CITY OF OREGON CITY HISTORIC REVIEW BOARD AGENDA

- a. HR-25-00014: New construction of a 6-unit multi-family building at the Sarah Hughes House (1102 7th St)

REQUEST: Request to add a new 6-unit multifamily structure on the same lot as the designated historic Sarah Hughes House

REVIEWER: Jude Thaddaeus | Planner

1 BIKE LOCKER
0.2-SD 1/2" = 1'-0"

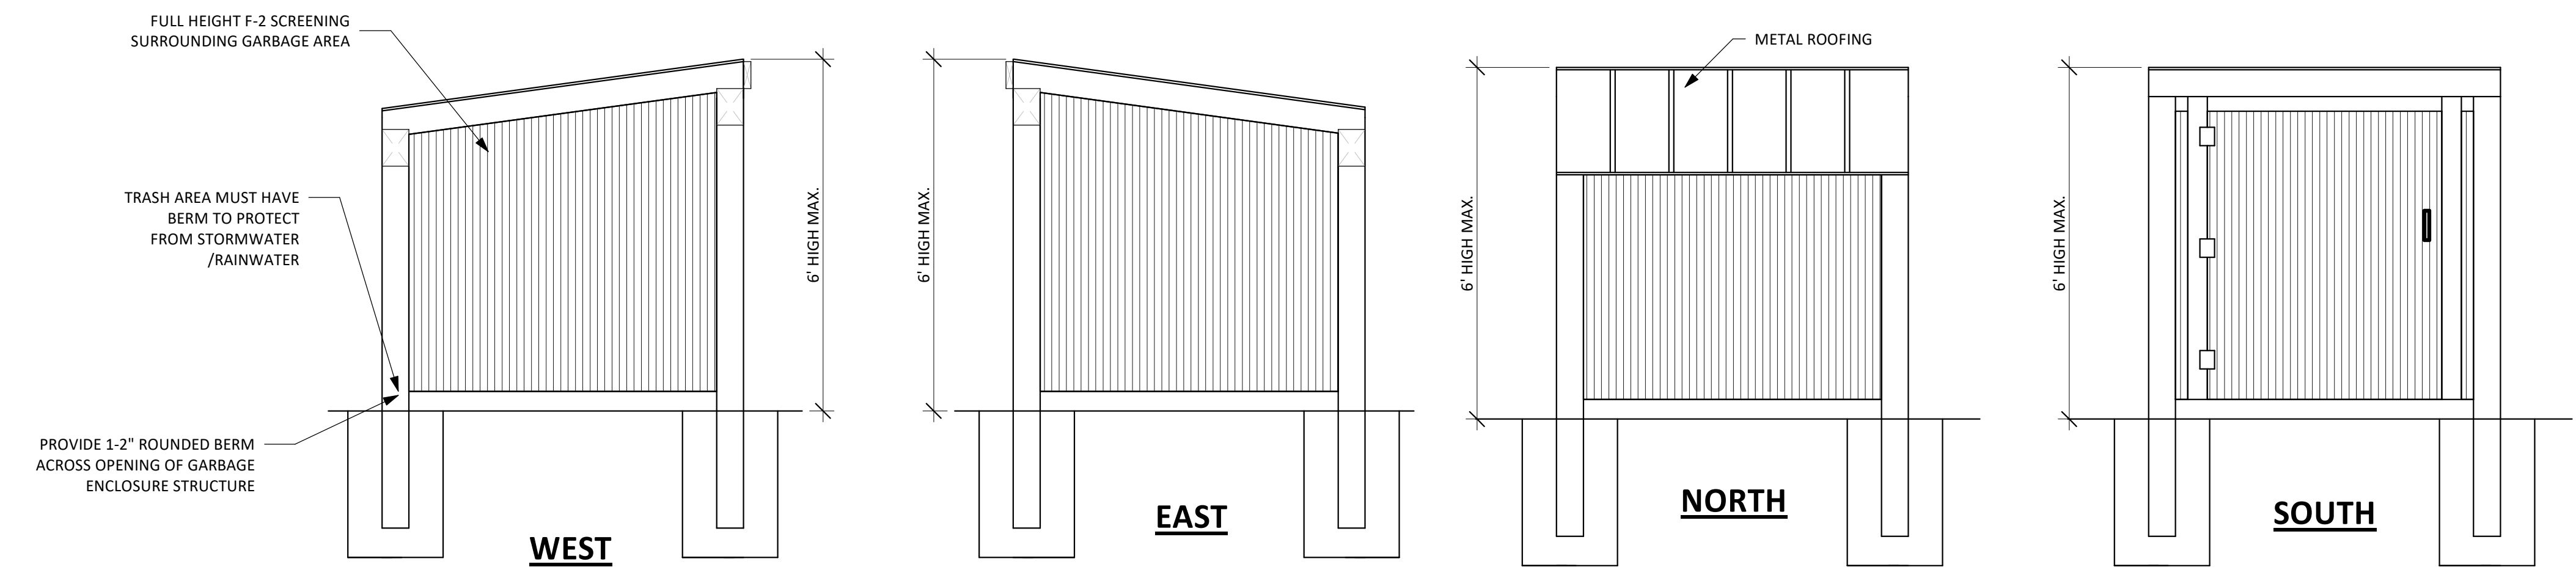
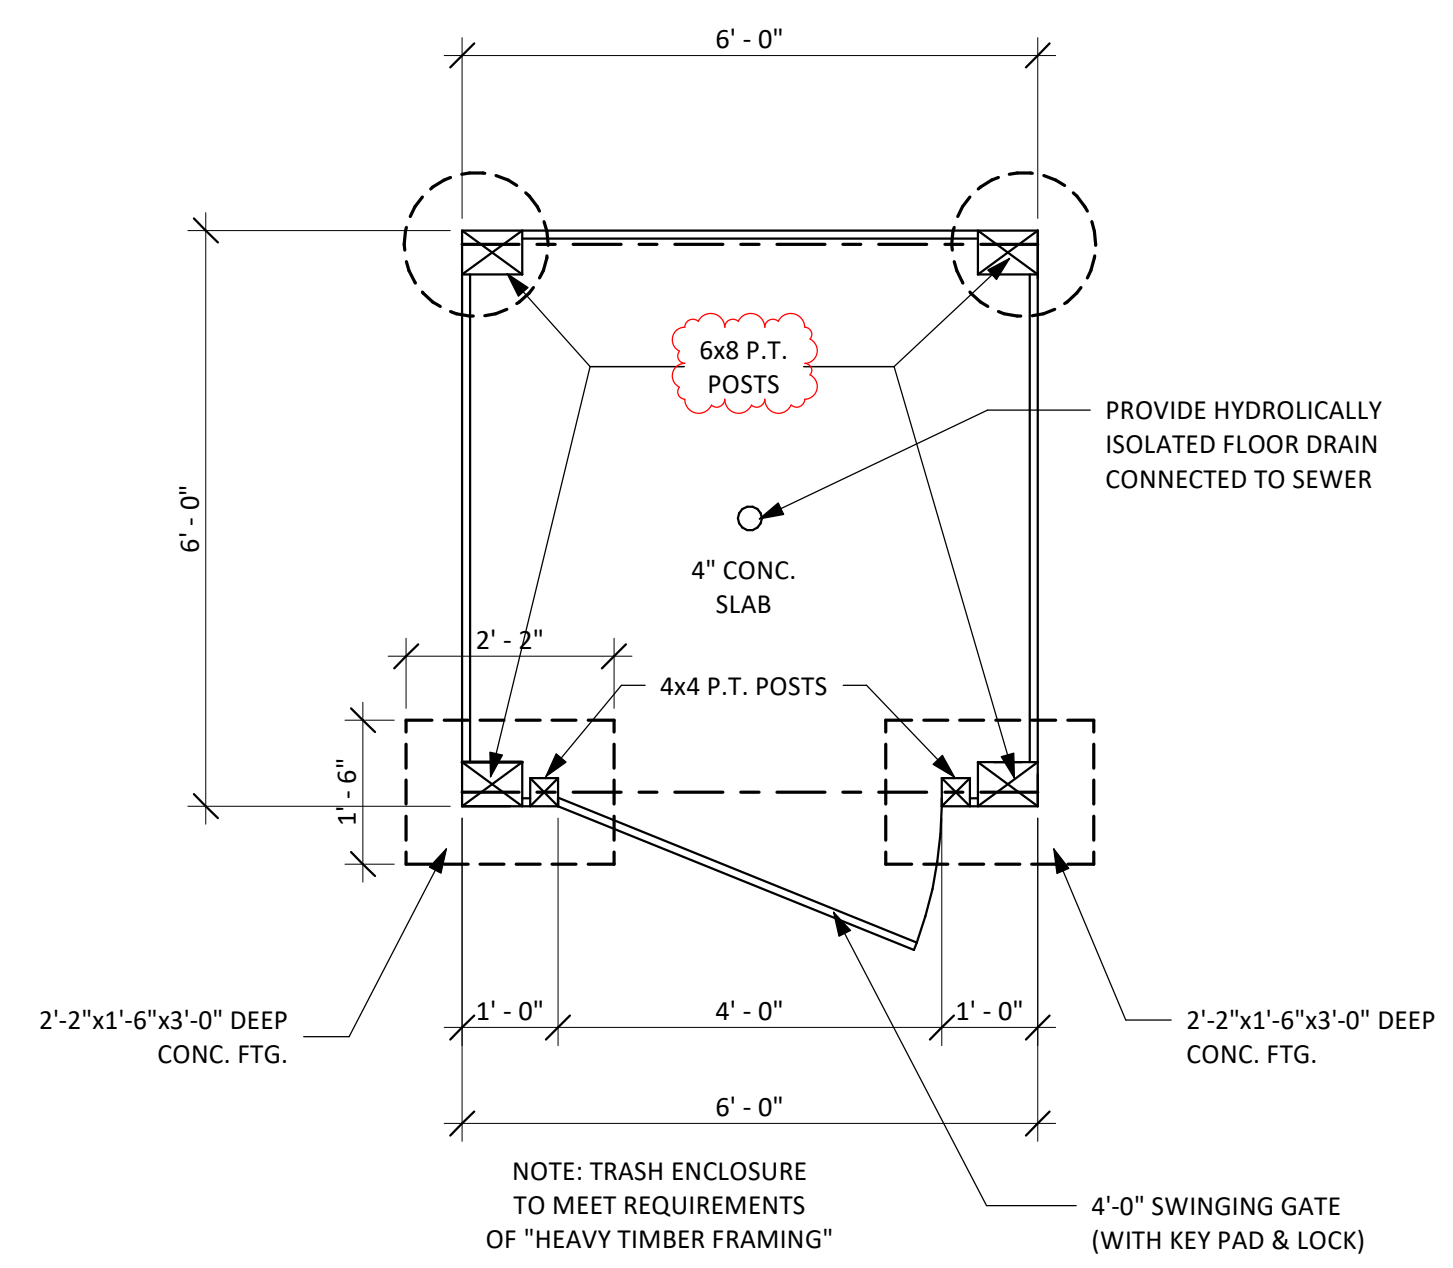
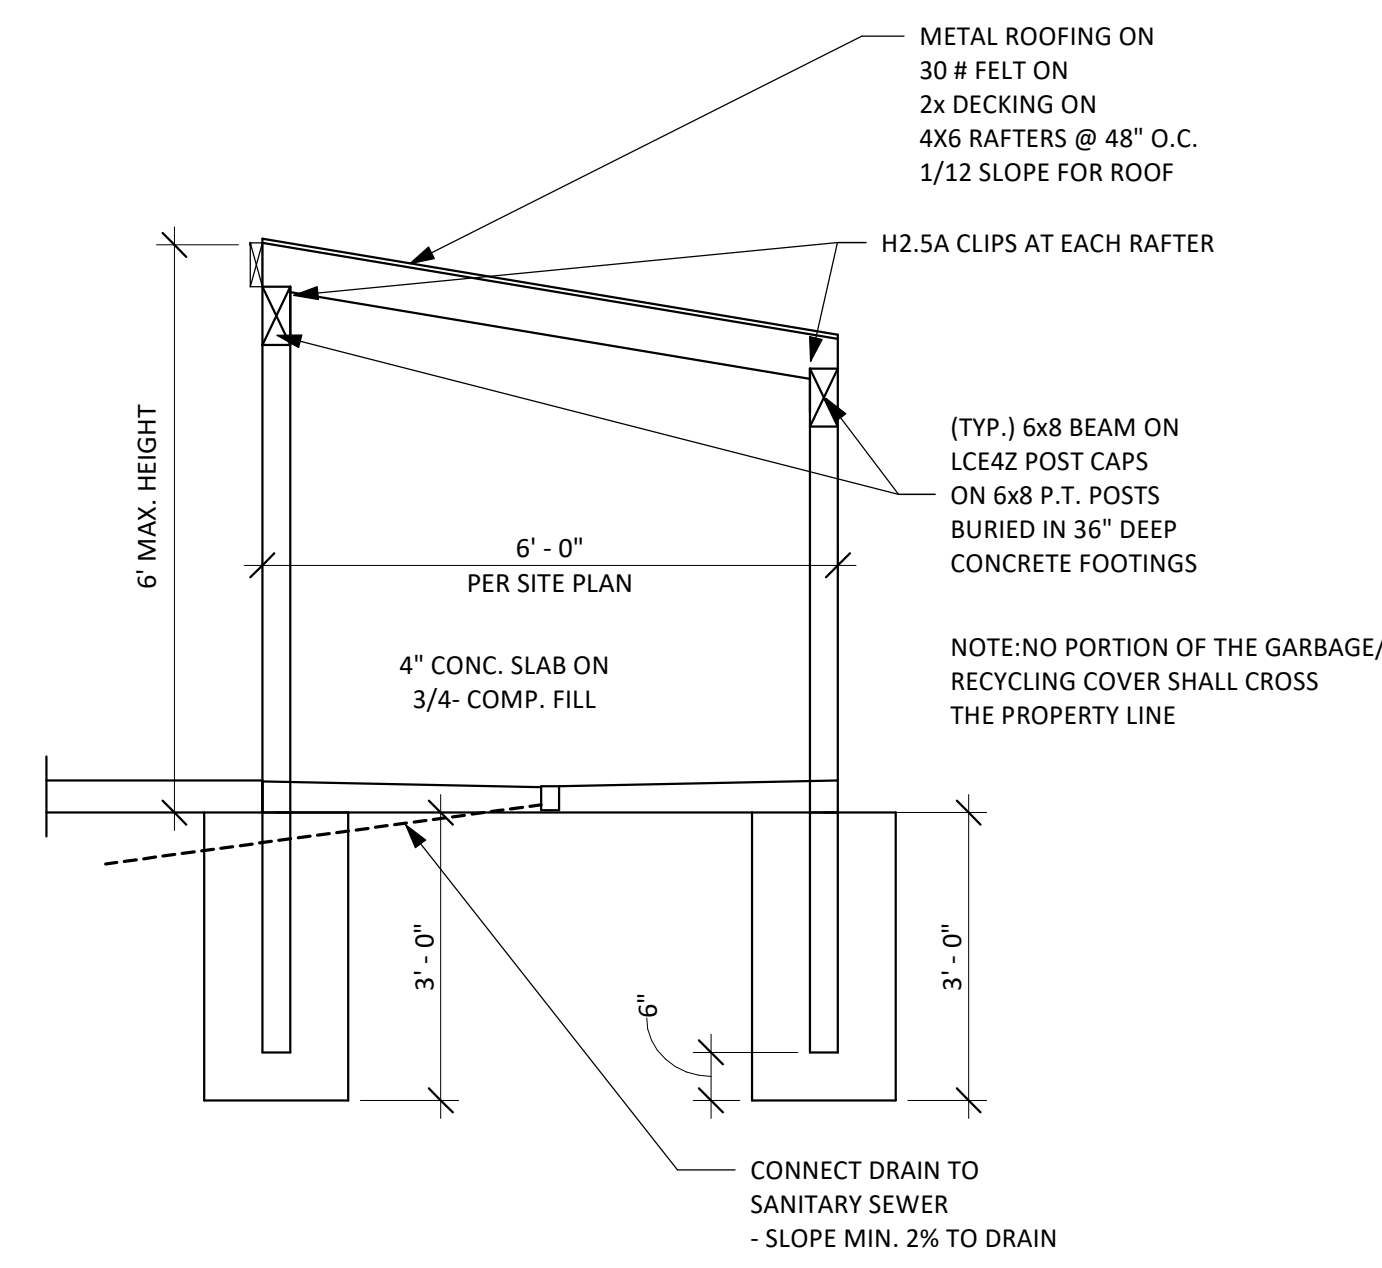
Staff Comments: The applicant proposes a 6-foot high, 33 square foot bicycle parking shed use metal shed roofing on a 1/12 slope and cedar fencing for siding. Post materials are unclear based on the revised plans. Historic Review Board Policy 7 requires accessory structures under 200 square feet to be sided, roofed, and painted to match the associated landmark in order to be approved by Staff. This structure would not match the Sarah Hughes House. The front and side façades of the structure would be visible from JQ Adams St, with the side of the structure being visible from 7th St, albeit 56 feet back from the 7th St right of way and 37 feet back from the front façade of the Sarah Hughes House. The structure is to be located between the right of way abutting JQ Adams St and the side façade of the Sarah Hughes House, approximately five feet northeast of the external stairwell facing JQ Adams St and 16 inches from the exterior wall of the landmark.

Side note: please clarify note on Sheet 0.2-SD that states: “Trash Enclosure to meet requirements of “Heavy timber framing”. Per OSSC Table 2304.11, heavy timber posts are required to be 6x8’s. The Plan calls out 4x4 p.t. posts

1 ROOF PLAN
6 3/16" = 1'-0"

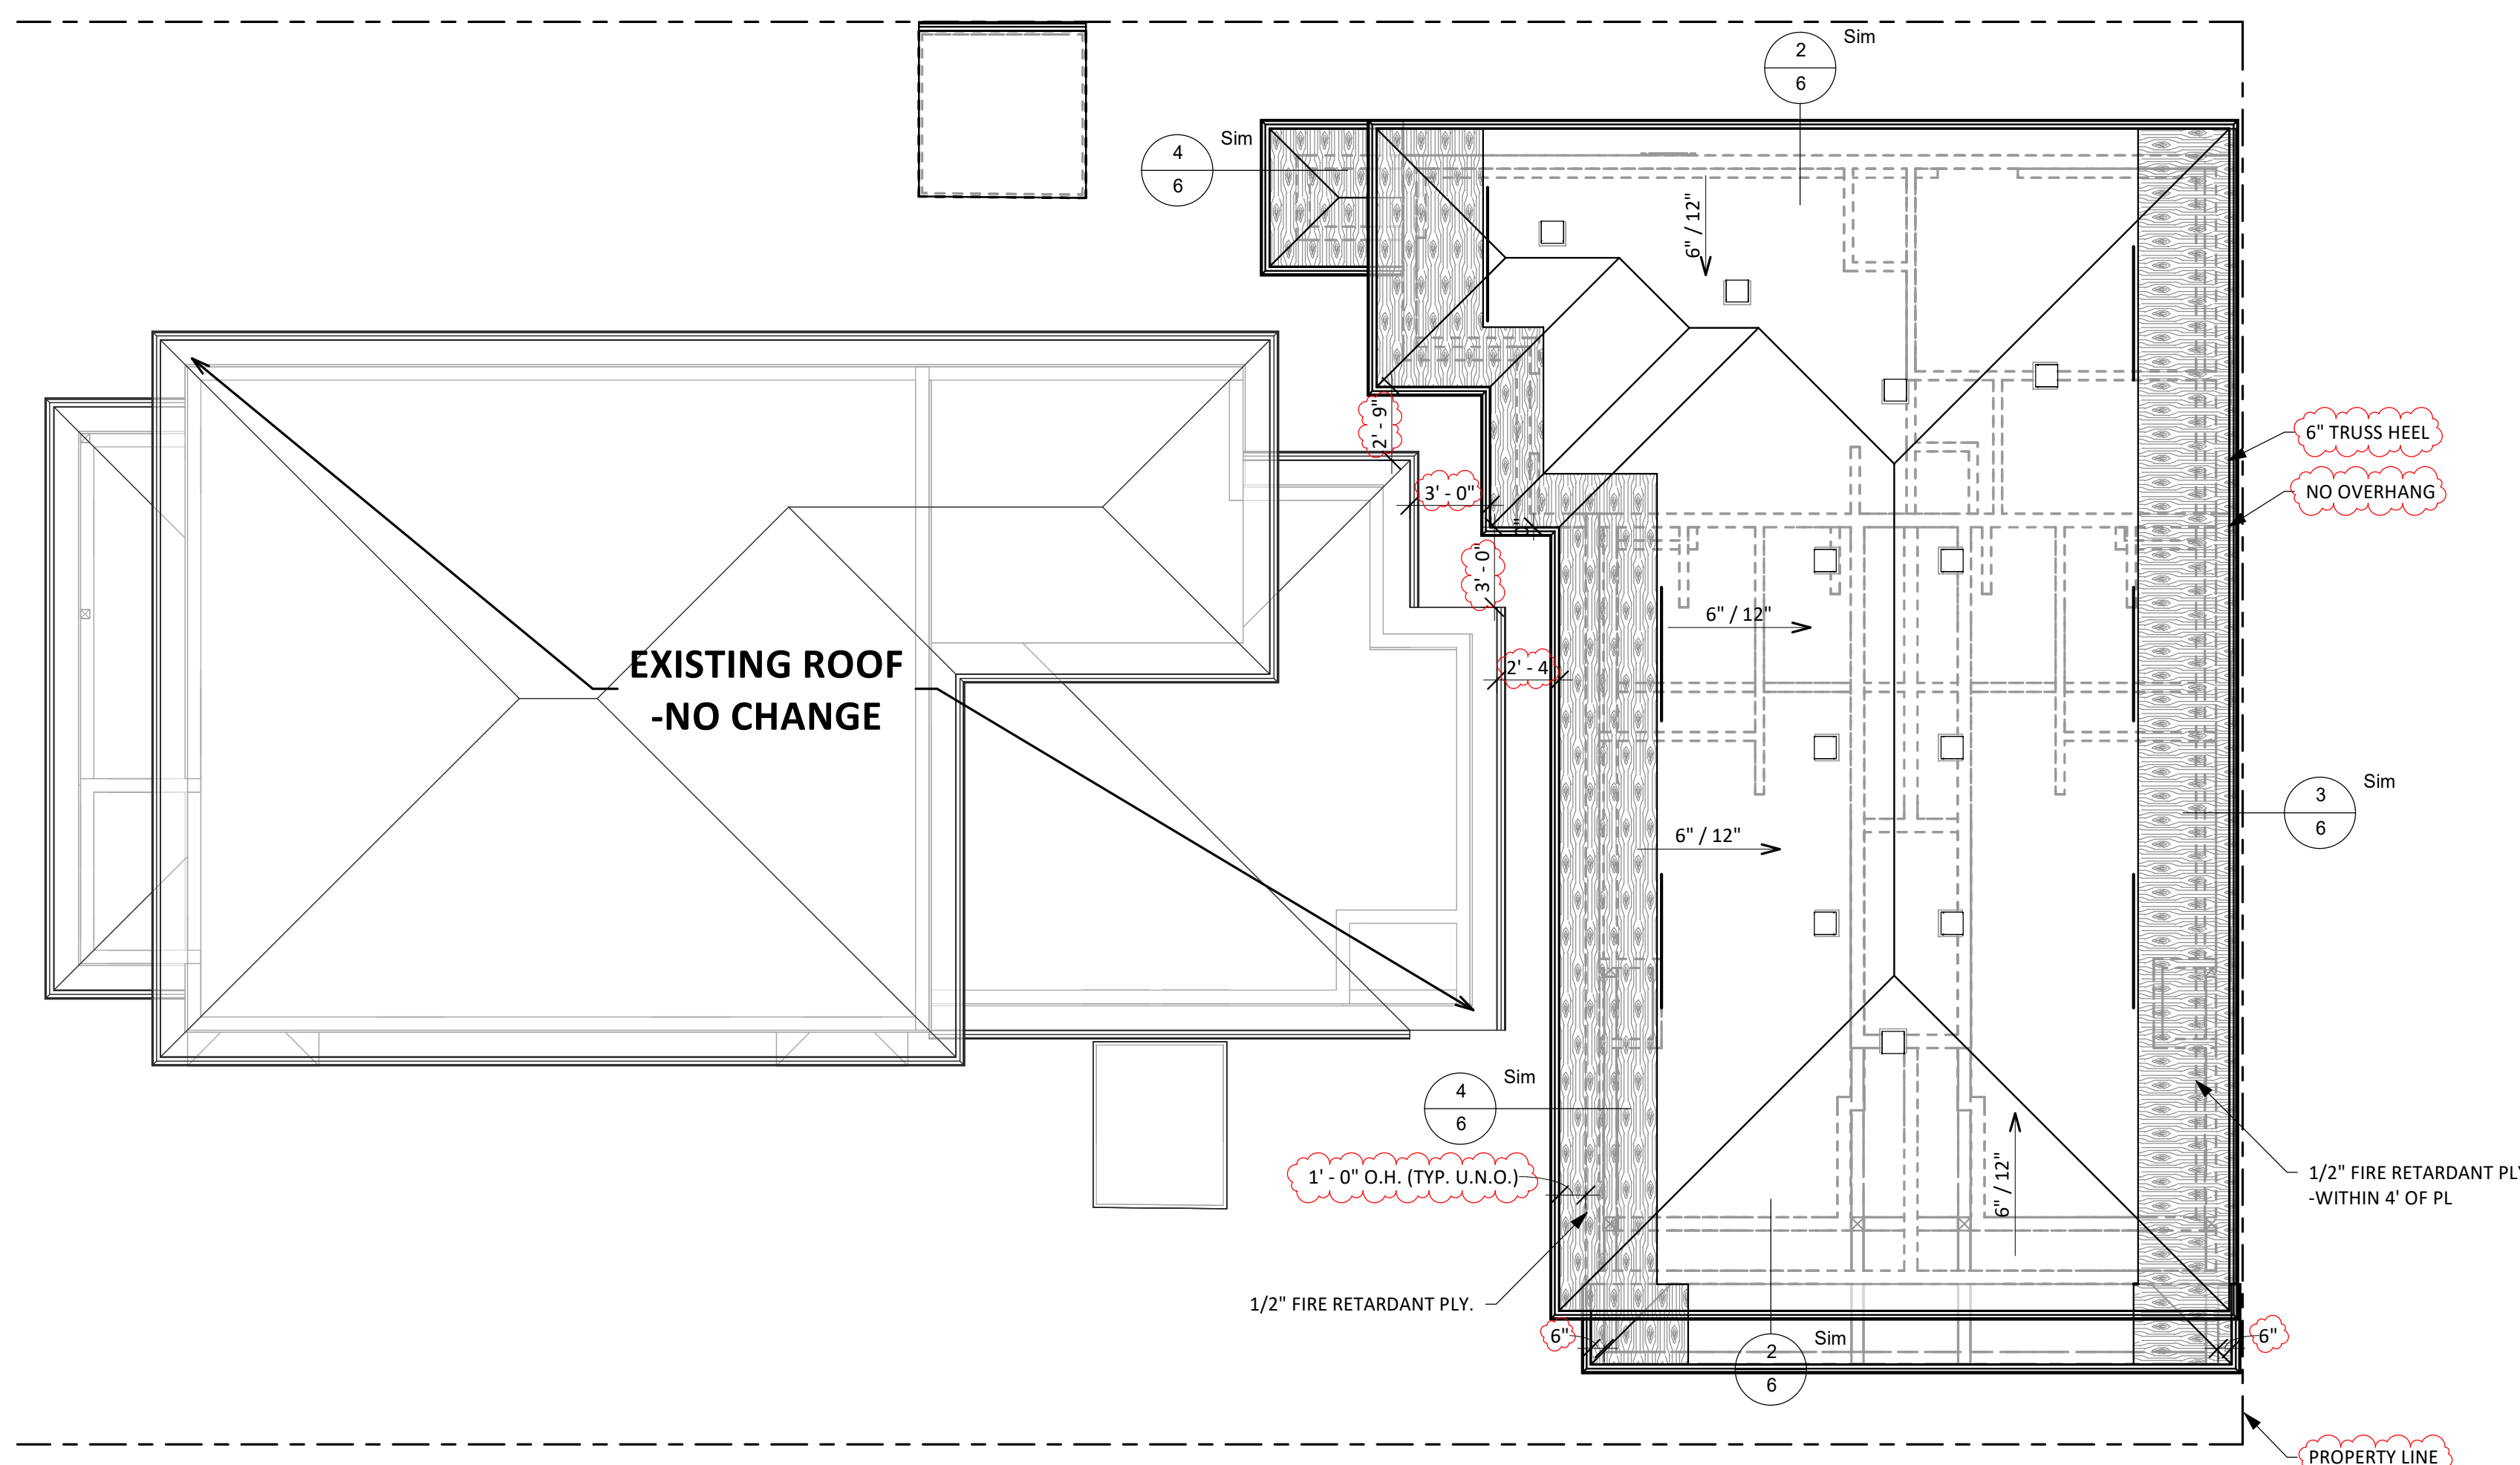
Roof plan showing 3.75 to 5 inches of gutter encroachment over the neighboring property line beyond the “No Overhang” situation.

3 TRUSS DETAIL (W/ COBRA
INTAKEPRO INTAKE VENT)
6 3/4" = 1'-0"

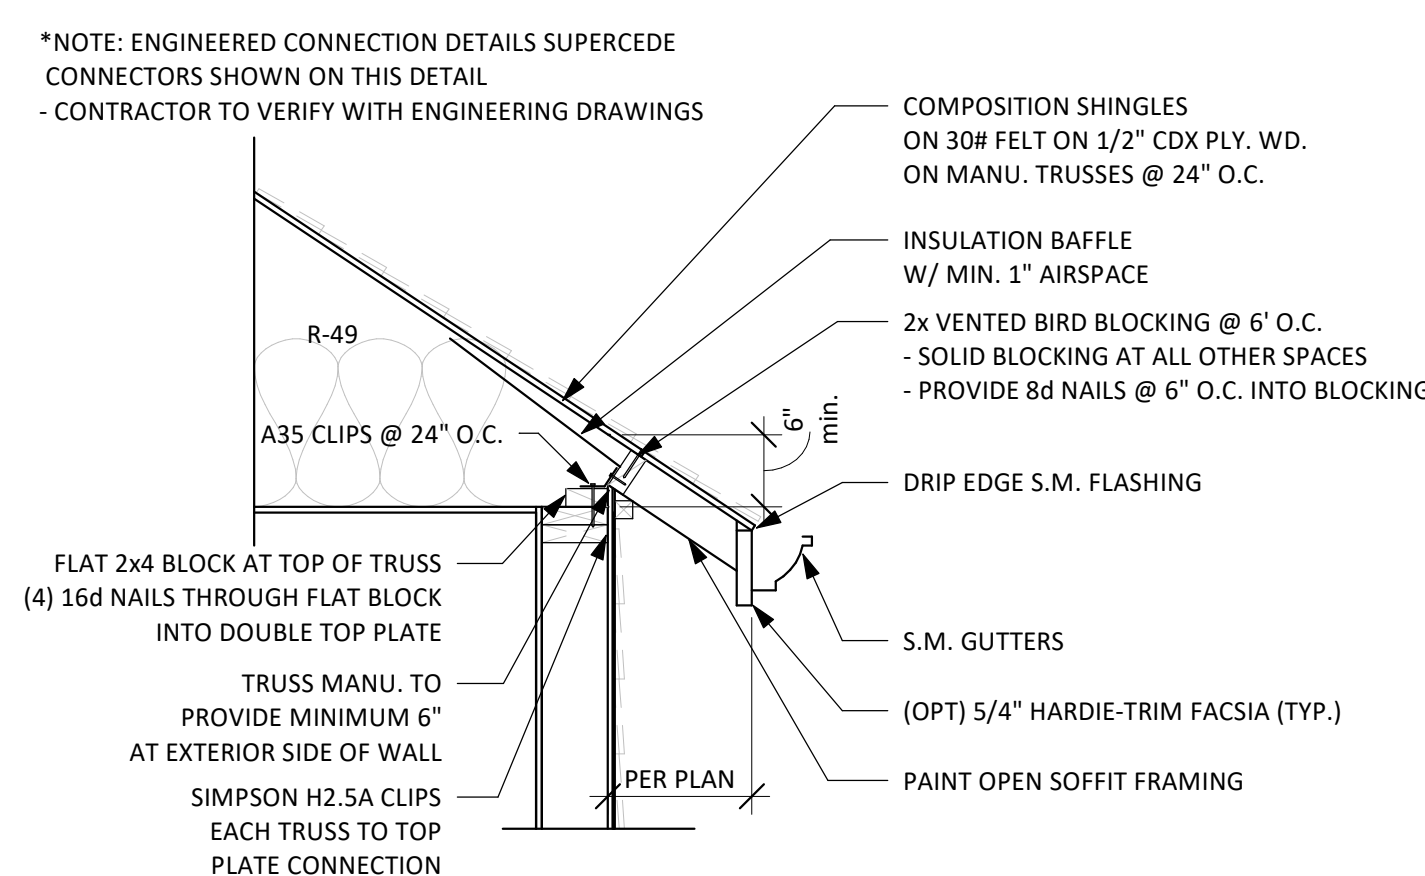
Plan detail showing a 5-inch gutter projecting beyond the “No Overhang” line, and therefore across the lot line shared with 612 JQ Adams Street
